NP-12-0004
March 2, 2012

Subject: Exelon Nuclear Texas Holdings, LLC
Victoria County Station Early Site Permit Application
Response to Request for Additional Information Letter No. 15
NRC Docket No. 52-042

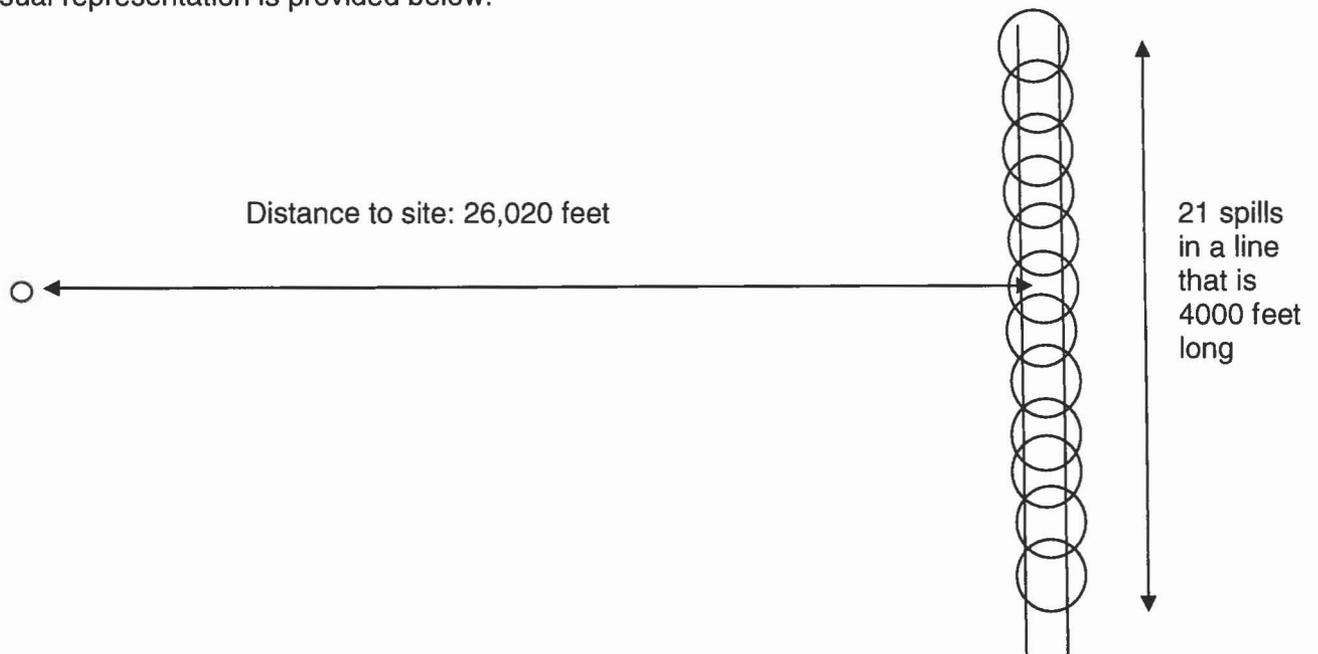
RS-002 and RG 1.206 provide guidance regarding the information that is needed to ensure potential hazards in the site vicinity are identified and evaluated in order to meet the siting criteria in 10 CFR 100.20 and 10 CFR 100.21. Flammable Vapor Clouds (Delayed Ignition) due to waterway traffic is addressed in SSAR Section 2.2.3.1.2.2. The applicant used the ALOHA model to determine the distance to the LFL (Lower Flammable Limit) and 1 psi overpressure threshold for each of the chemicals evaluated. The total inventory of each chemical is assumed by the applicant to be 10,000,000 pounds (5000 tons). However, the applicant stated in the SSAR that the modeling was performed with the ALOHA model constraints of a puddle area of 337,986 square feet (31,400 square meters), and spill amount limited to 242 tons. Therefore, the complete inventory of 10,000,000 pounds is not properly accounted for in the analysis in determining the LFL and 1 psi overpressure distances. The applicant stated that the model constraints were considered to be acceptable due to the narrow constraints of the Victoria Barge Canal. The NRC staff requests the applicant apply a reasonable adjustment to the modeling approach in order to reflect the complete inventory of each chemical considered.

A revision of the SSAR hazards evaluation was performed to address the total inventory of 10,000,000 lbm specified in Regulatory Guide 1.91 for each chemical. In order to simulate the 10,000,000 lbm both within the constraints of the Victoria Barge Canal width of 250 ft and the ALOHA code limitations, the following approximation was adopted. The spill is represented by 21 spills of mass 242 tons each (totaling 10,164,000 lbm) in a chain of 300 foot diameter circles at separation distances of 200 feet center to center. A visual representation is provided below:

To evaluate the lower flammability limit (LFL) concern, the 21 plumes are superimposed at the site, and the “threat at a point” option of Aloha was used. The point utilized is the VCS Power Block boundary, which is 26,020 feet from the barge canal. For the example of Butadiene, which was the limiting plume per the original evaluation, the “threat at a point” directly downwind of the center of the spill indicates a peak concentration of 121 ppm (as compared to a LFL of 16,900 ppm). The peak concentration from the edge spill (i.e. end of spill 2,000 feet from centerline) is 90.9 ppm. Conservatively assuming all spills would produce a peak concentration of 121 ppm, the total concentration of all 21 plumes added together would be $21 \times 121 \text{ ppm} = 2541 \text{ ppm}$. This total concentration is well below flammable limits, and is therefore acceptable. Note: ALOHA uses the terminology Lower Explosive Limit (LEL) but that is commonly used interchangeably with LFL.
